# Lucan to City Centre Core Bus Corridor Scheme

## NTA Observations on the Proposed Scheme Submissions

May 2023

**Figure 2.1.3.5.4 Extract from GDA Cycle Network Plan included as Image 2.1 in Chapter 2 Need for the Proposed Scheme in Volume 2 of the EIAR with suggested alternative cycle route shown**

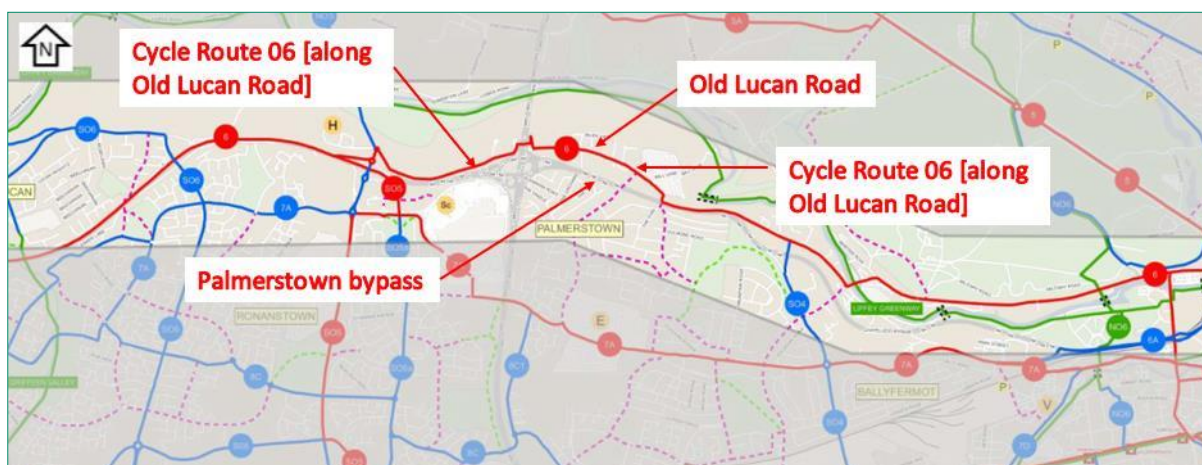
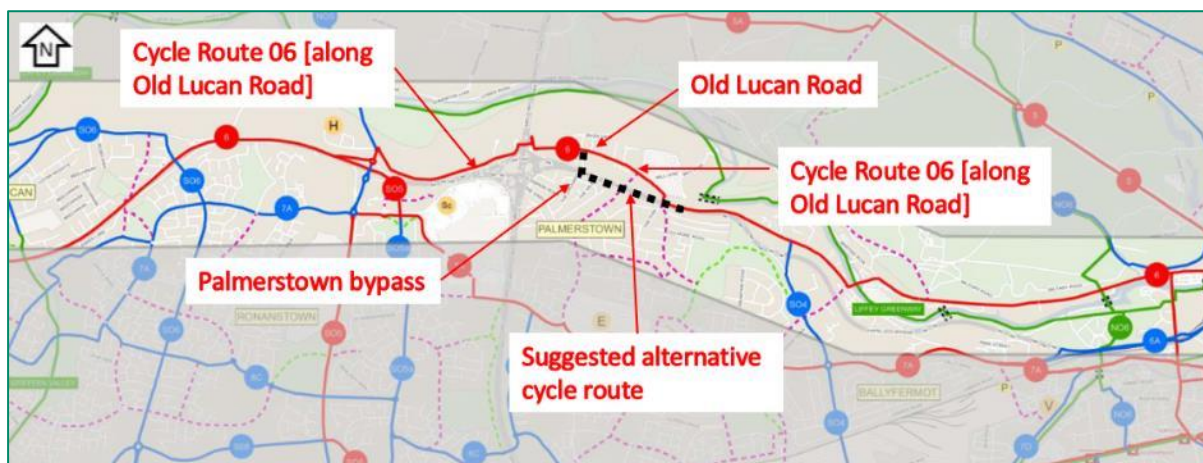
The submissions propose an alternative route for the Primary Cycle Route diverting off the Old Lucan Road at the old Fassenbridge Garage site (opposite the Old Beehive) and into the SHD development. However, it is unclear where the route should continue to after exiting the SHD, although it would be reasonable to assume it would continue along the Palmerstown bypass to connect with the shared area past the Applegreen petrol station at The Oval Junction, see Figures 2.1.3.5.3 and 2.1.3.5.4.
